**CITY OF TEMPE
DEVELOPMENT REVIEW COMMISSION**

**Meeting Date: 10/10/2017
Agenda Item: 3**

ACTION: Request for a Development Plan Review consisting of a new 8,311 s.f. commercial building for EMERALD CENTER, LOT 4 PHASE 1, located at 1746 West Warner Rd. The applicant is Huellmantel & Affiliates.

SHEET TITLE:	LANDSCAPE PLAN
ISSUE DATE:	08.10.17
DRAWN BY:	staff
CHECKED BY:	TJM
PROJECT No.:	
SHEET:

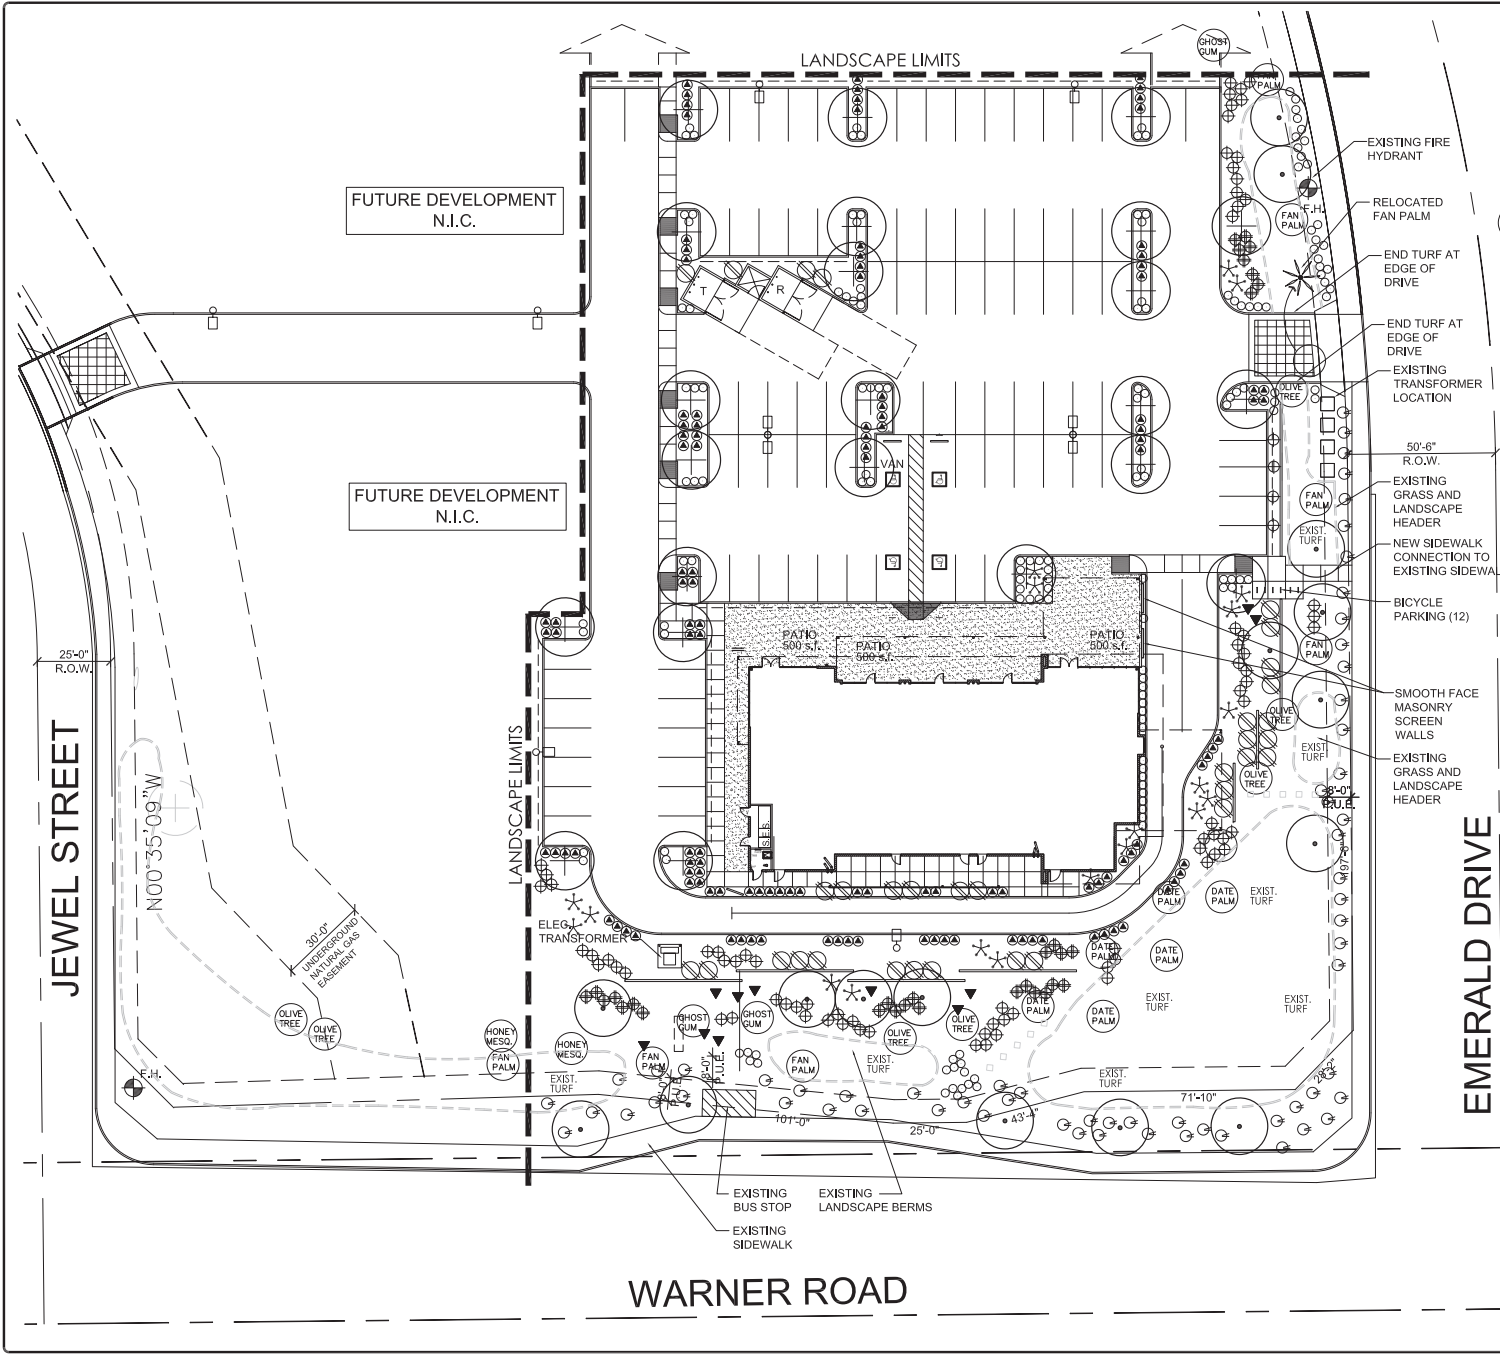
Live Oak trees are proposed within parking lot landscape islands, and a condition is included to replace the Live Oak trees with Swan Hill Olive in order to provide consistency with other projects in Emerald Center. Conditions are also included to replace several of the Ghost Gum trees along Emerald Drive and Warner Road with Swan Hill Olive to provide a greater variety in tree height and better opportunities for shade along the public sidewalks.

13. **Replace three (3) of the seven (7) Ghost Gum trees along Emerald Drive with Swan Hill Olive trees.**
14. **Replace the Fan Palm tree north of the driveway on Emerald Drive with a Swan Hill Olive tree, and relocate the Fan Palm elsewhere on the site.**

15. **Replace three (3) of the five (5) Ghost Gum trees adjacent to the sidewalk on Warner Road with Swan Hill Olive trees. One of the Ghost Gum trees that shall be replaced includes the one directly west of the bus stop.**
